## **Bear Creek Stables Ad Hoc Committee**

### **Attachment 1B - Working Group Questions/Comments and Staff Responses Table**

This table was provided to the Bear Creek Stables Ad Hoc Committee and working groups prior to the September 12, 2024 Ad Hoc Committee Meeting #4. Additional staff feedback on information presented at the Ad Hoc Meeting #4 will be provided at the September 19, 2024 Ad Hoc Committee Meeting.

**L2.1**

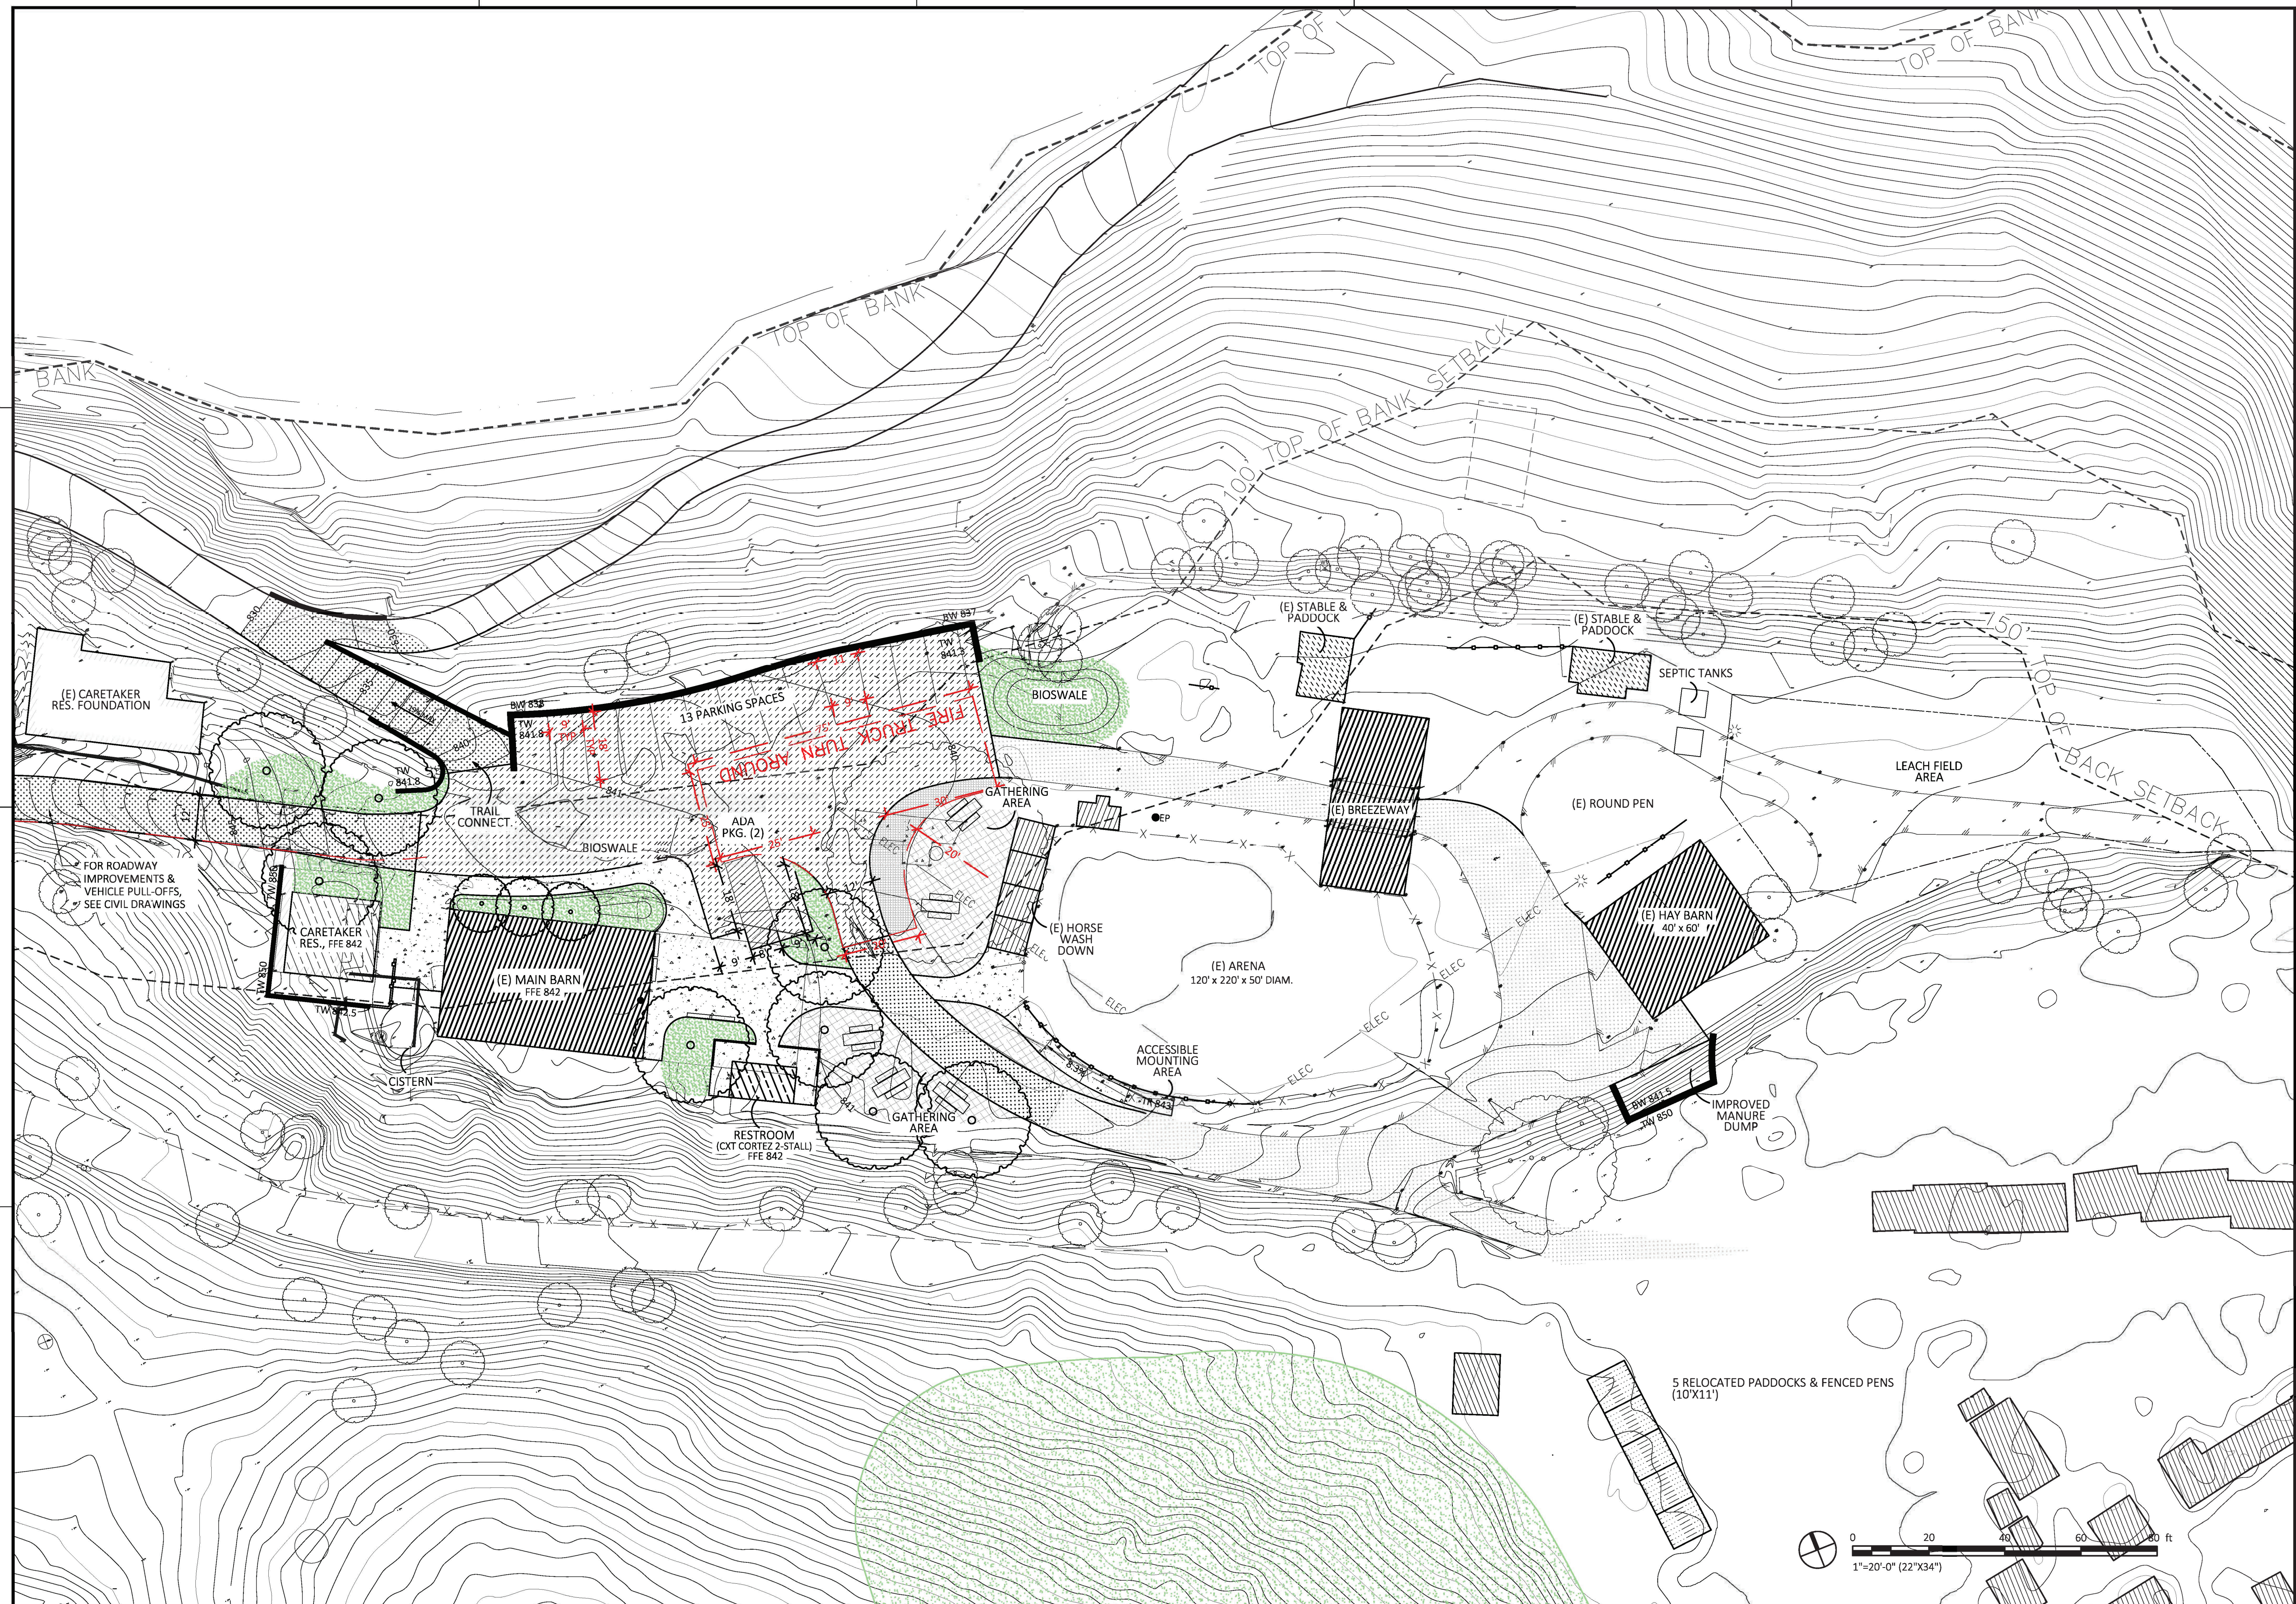
| Date      | Topic | Comment/Questions  | District Response  | County Question | County Response | Preliminary Feedback       |                |                           | Additional Feedback / Considerations           |
|-----------|-------|--|--|-----------------|-----------------|----------------------------|----------------|---------------------------|--|
| 8/14/2024 |       | Can we please be sent the digital files for sheets L2.1, C1.1 and C1.2, please. What is the scale of those drawings?   | See Attachment 1. the size/scale of these drawings, which are as follows:<br><br>Sheet Full Size Full Scale<br>L2.1 22x341" = 20'<br>C1.1 22x341" = 40'<br>C1.2 22x341" = 20'<br><br>If the FWG chooses to fit/print these drawings at half size on 11x17 paper then the scales should change from 1" = 20' to 1" = 40', and from 1" = 40' to 1" = 80' (though is not always exact due to different print settings).   | -               | -               | -                          | -              | -                         | See attached Plan Sheets.                      |

**District Residential Housing**

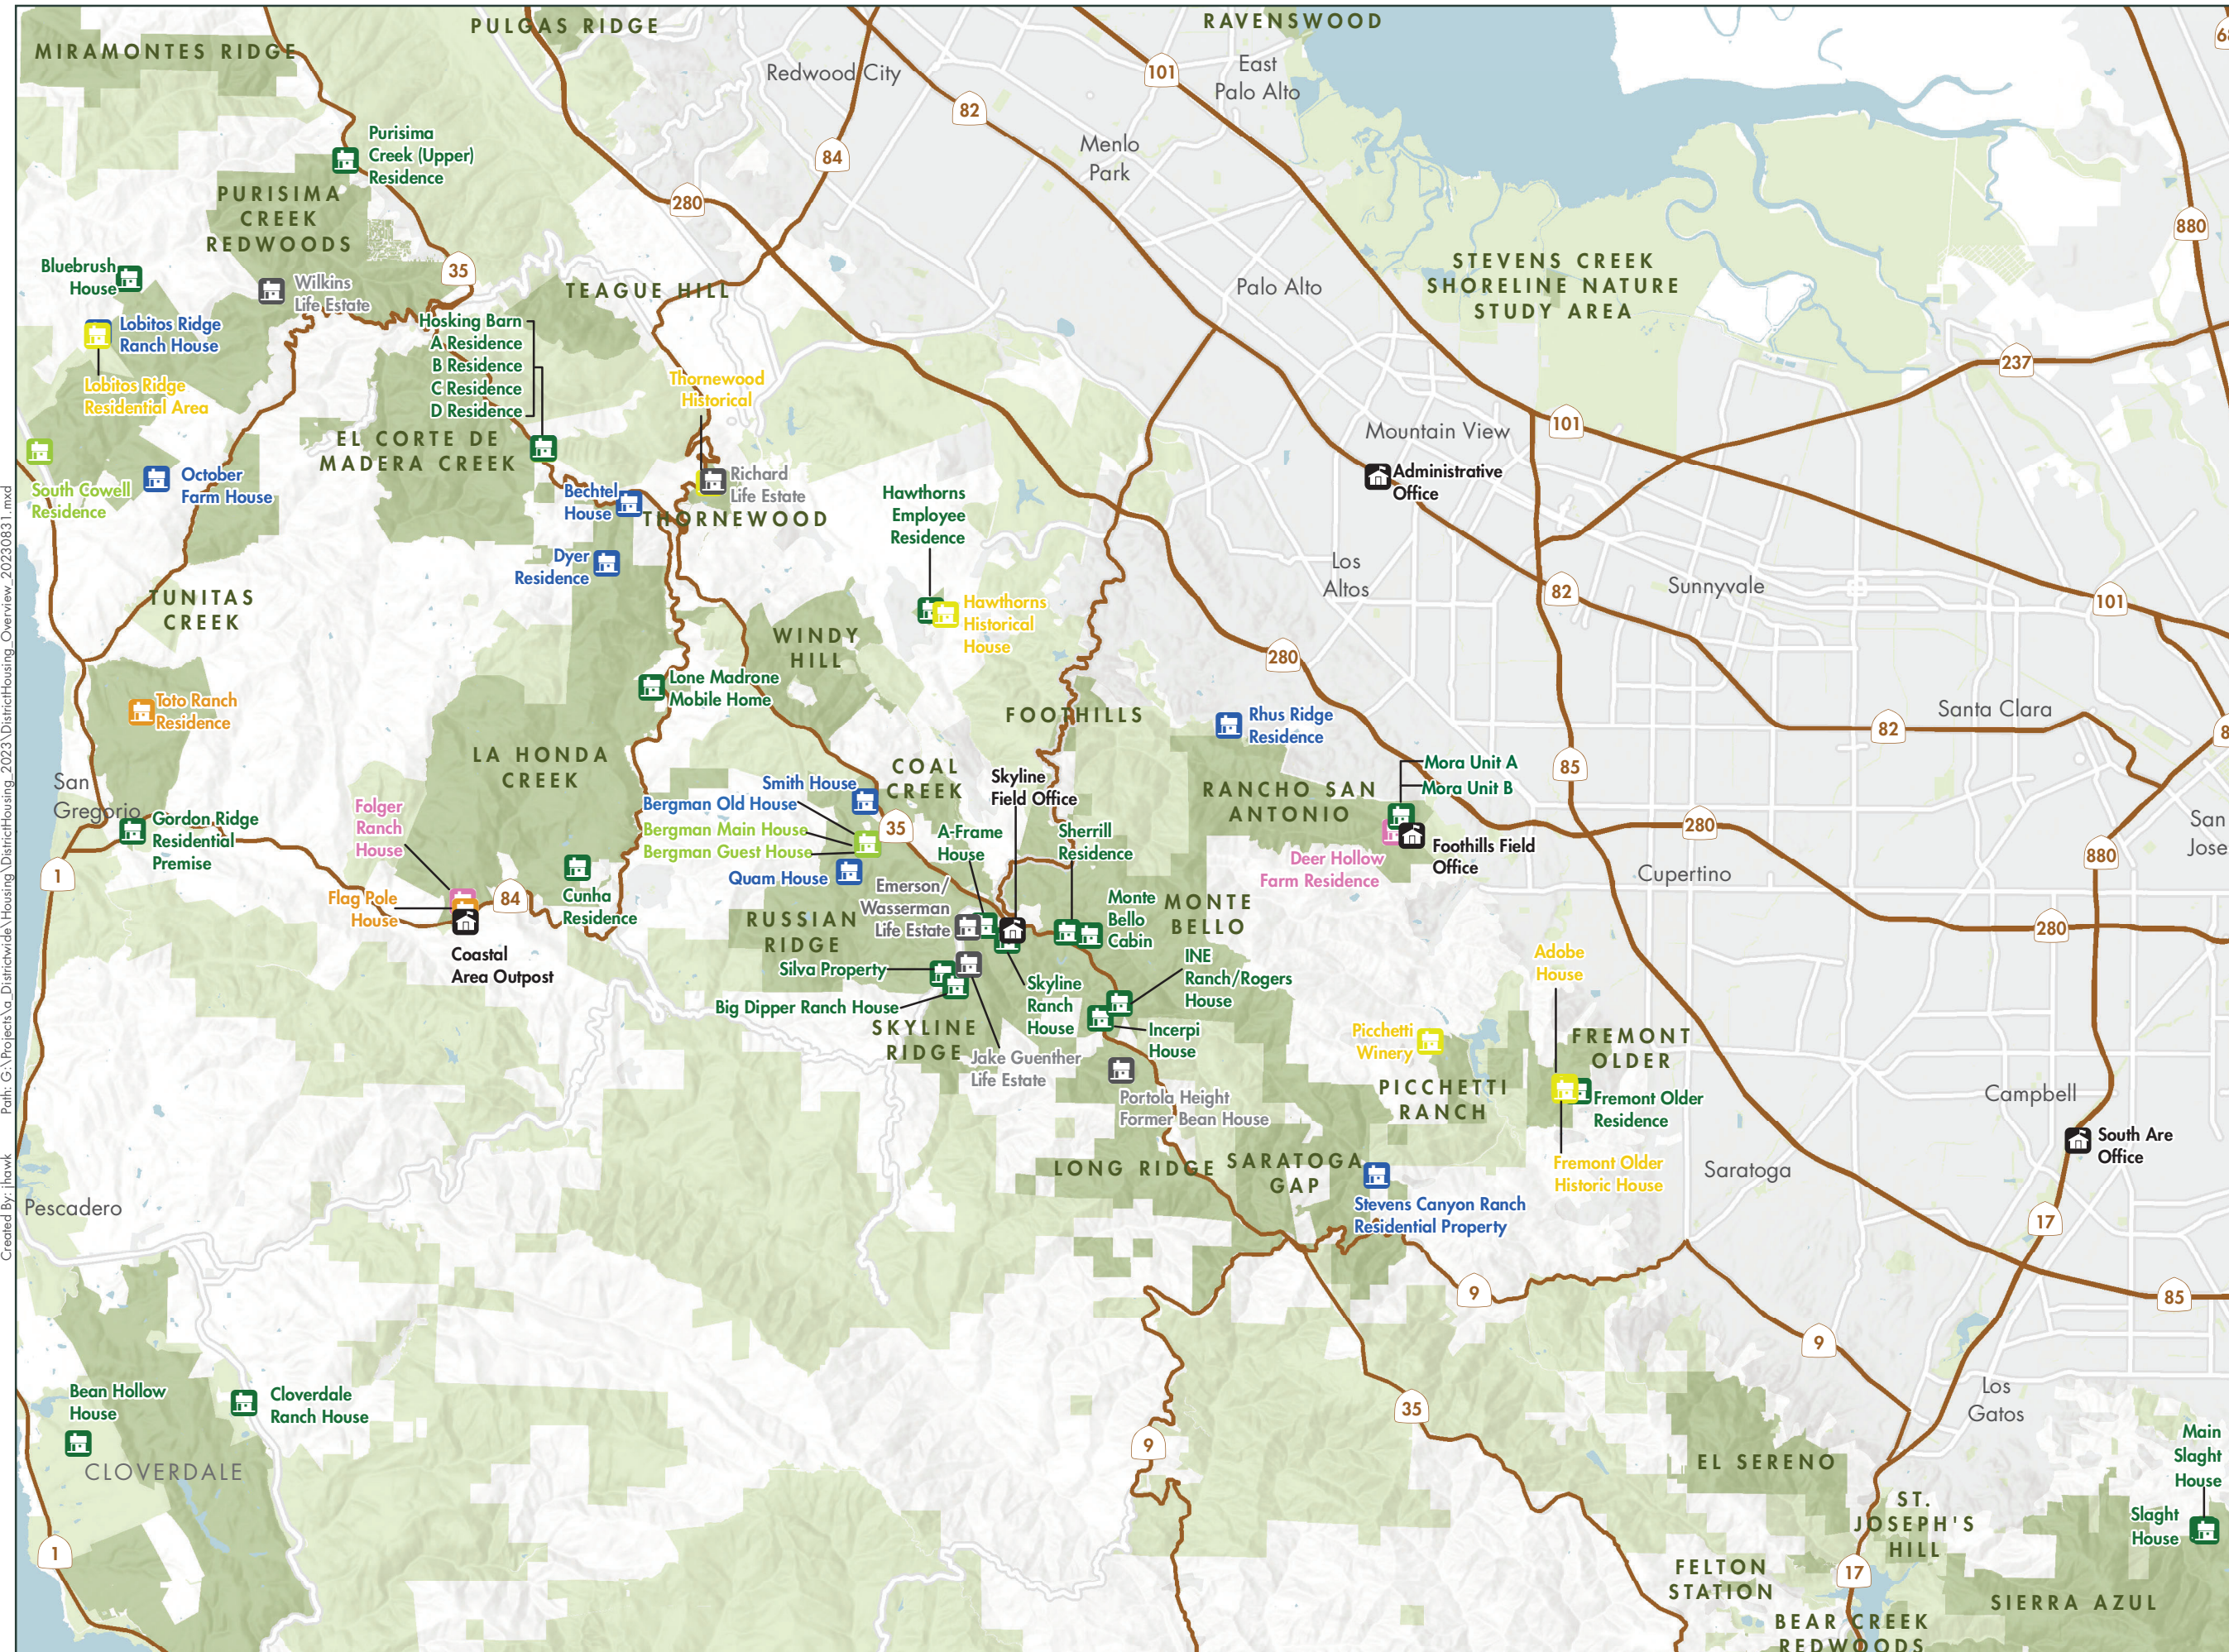
| Date      | Topic | Comment/Questions  | District Response  | County Question | County Response | Preliminary Feedback       |                |                           | Additional Feedback / Considerations           |
|-----------|-------|--|--|-----------------|-----------------|----------------------------|----------------|---------------------------|--|
| 8/14/2024 |       | In consideration of a potential ranger housing unit, which was brought up both by Architecture, Site Design ad hoc as well as the Programming ad hoc, what would be considered the better option for the District: a one bedroom or two bedroom unit? Anything else that should be considered besides at least some aspect of privacy? | A 2-bedroom house would provide more flexibility for a staff residence to allow for housing staff with a family or roommates. A ranger residence's purpose is to have rangers available to respond to emergencies, they would not necessarily be available to deal with issues at the stables. If a ranger residence was located at Bear Creek it would preferable be separate from the stables. Given the volume of service requests from property management and the maintenance crew, if a second house was available at the stables it might be prioritized for Midpen maintenance or property management staff (depends on involvement of Midpen in ongoing management of the stables). The other factor to consider is that if there is no staff interest, Midpen typically rents the property to the public. A house in the stables may not be desirable for staff and the public. Midpen currently has 27 employees living in housing on preserves, see Attachment 2. The map was last updated in 2023. We have typically used existing structures for housing. Developing new structures for staff was explored at several different locations but was not pursued further due to the high cost of building a new house (examples: La Honda-Sears Ranch, Sierra Azul-Myer property, and Siera Azul-Twin Creeks). One option to consider could be to design the caretaker residence with the possibility of adding an additional dwelling unit ADU in the future. Please note that all these options could potentially significantly increase project costs. | -               | -               | Low                        | Low            | Low                       | See attached District Residential Housing map. |
